Interactive comment on “Balancing energy and environmental concerns: the case of the Kayraktepe dam, Turkey” by Ö. Sever et al.

Received and published: 16 January 2013

We would like to thank for the valuable comments of the reviewer #1. We have reviewed referee' suggestions, and the necessary changes and explanations will be made in the revised article. An item-by-item summary of our responses to the review comments is provided in this sheet.

Fig. 1. Figure 1b

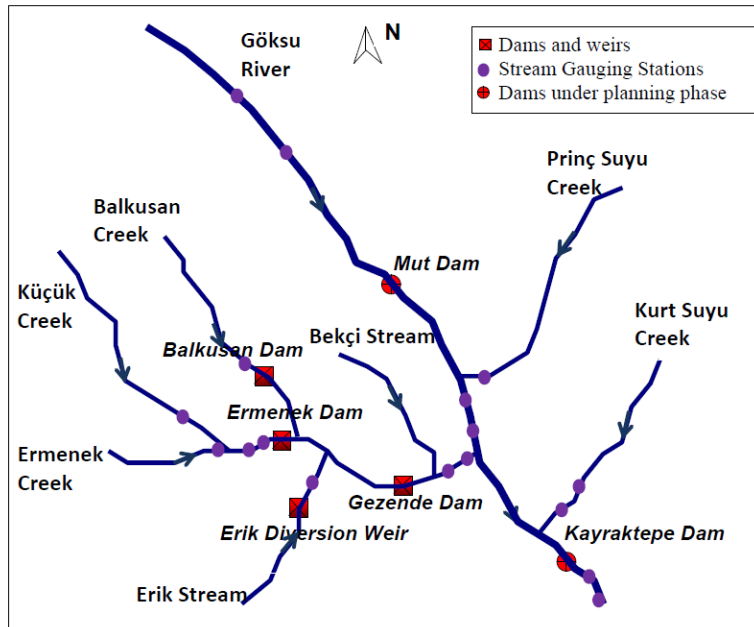
We will arrange Table 1 according to your and editor’ suggestions. Page 11773 (line 13) figure 1 is not very clear. It would be useful to indicate which dams have been built and which are planned.

The Figure 1 is placed very small, we will ask editor if they can enlarge it. In addition we re-draw the Figure 1 which is attached.

Figure 3 Comparison of Kayraktepe 1997 and Kayraktepe 2010 with respect to inundated area.

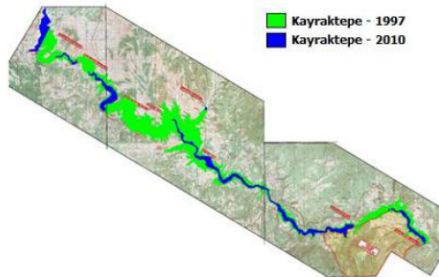
Technical corrections The English could be tightened somewhat. The figures are not very clear and could be improved by including more detail. A figure showing the difference in area inundated by the different schemes would be useful

dropower plants. The main dam has a height of 53 m and the total lake area will be 820 ha. Number of inundated villages located in upstream of the dam was 43 and it will force about 2200 people to resettle elsewhere according in Kayraktepe-1982 schema. It is reported that there will be 11 village with 5000 ha land will be flooded if Kayraktepe 1997 will be realized. However, In Kayraktepe 2010 schema, a dramatic reduction in expropriation area by % 83.5 was achieved, where originally 5000 ha area was reduced to approximately 820 ha. None of the villages at the upstream will be inundated. A plan view of Kayraktepe-1997 and Kayraktepe-2010 alternatives were prepared by using a 1/25000 scaled topographic map and can be seen in Figure 3.
